**DEVIATION REQUEST
AND DECISION FORM**

Project Name : The Commons at Falcon Field Deviation No. 3 Date: 6/2/2023

Deviation Exhibit A
Deviation Requests

Commons at Falcon Field (LSC# 234220)

Deviation Exhibit C

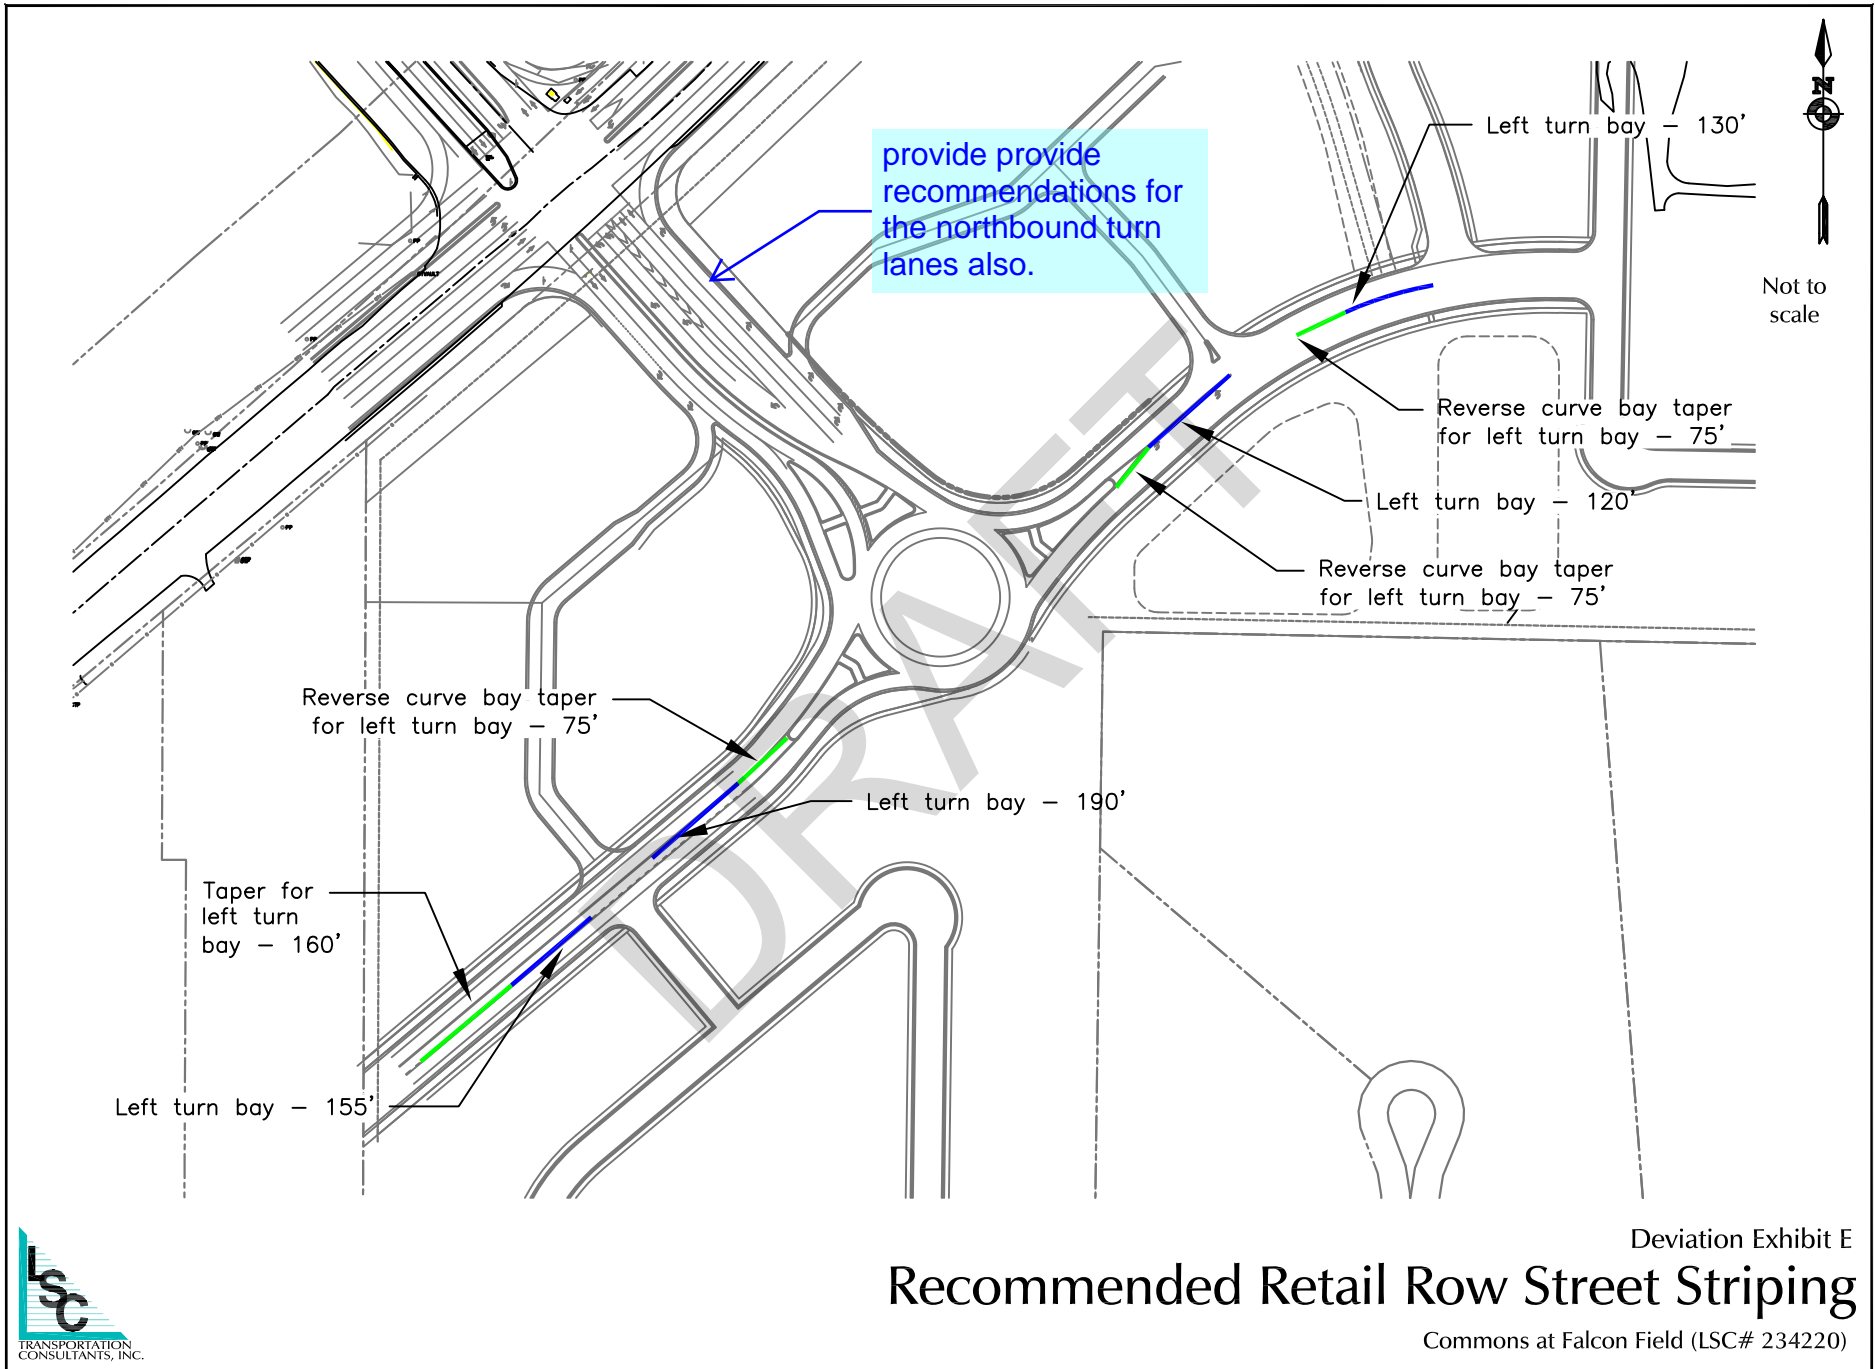
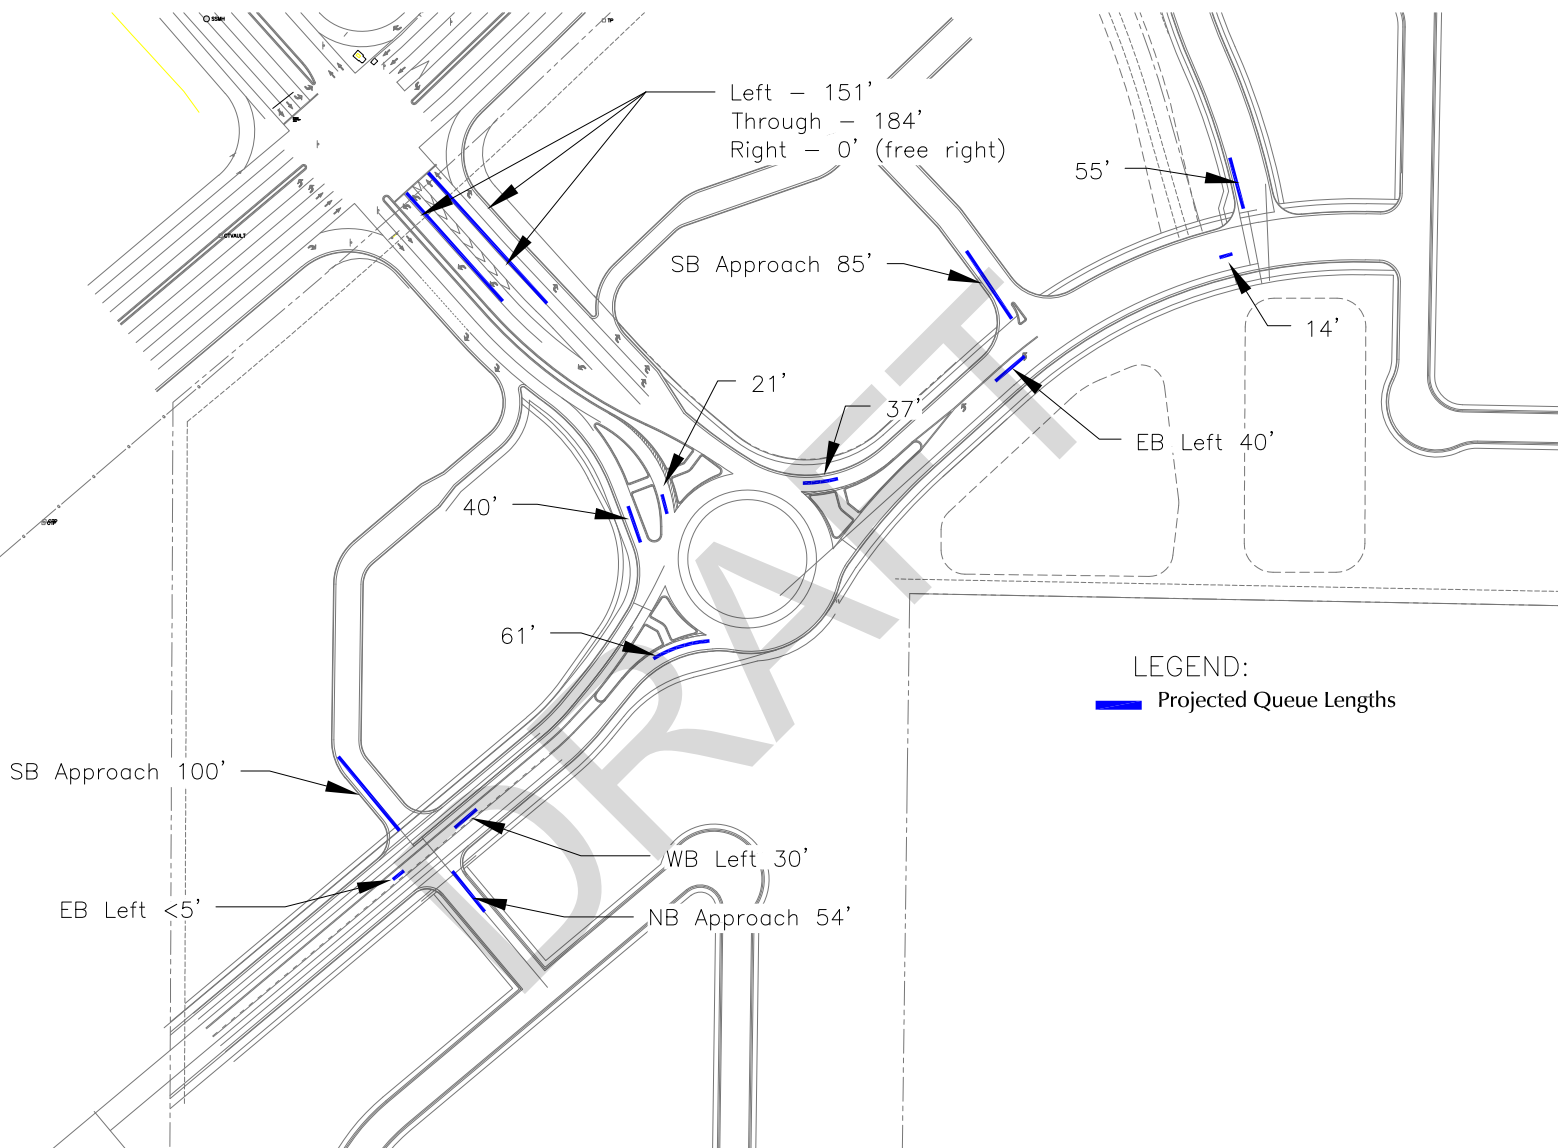
Please also indicate the proposed lane/taper/storage lengths for the westerly access turn lane, the left turn lane at Jackdaw Drive, and the northbound turn lanes along Woodmen at Hwy 24.

Please also discuss the northbound turn lanes at Hwy24/Woodmen as these would also not meet criteria

The turn bay lengths on the approach to Woodmen/US Highway 24 are a function of the spacing between Woodmen and the proposed roundabout, and the spacing between the intersections is constrained. Please refer to Deviation Exhibit C for the proposed turn-bay lengths and Deviation Exhibit F for the estimated queue lengths. The distance is constrained by the roundabout location which is limited due to the shape of the properties and the locations of the property lines. Please refer to the separate Deviation No. 1 for intersection spacing.

The 2040 queueing analysis contained in the TIS indicates that the proposed left-turn lane lengths for the northbound approach to the Woodmen Road/US Highway 24 intersection will be able to accommodate the projected queues.
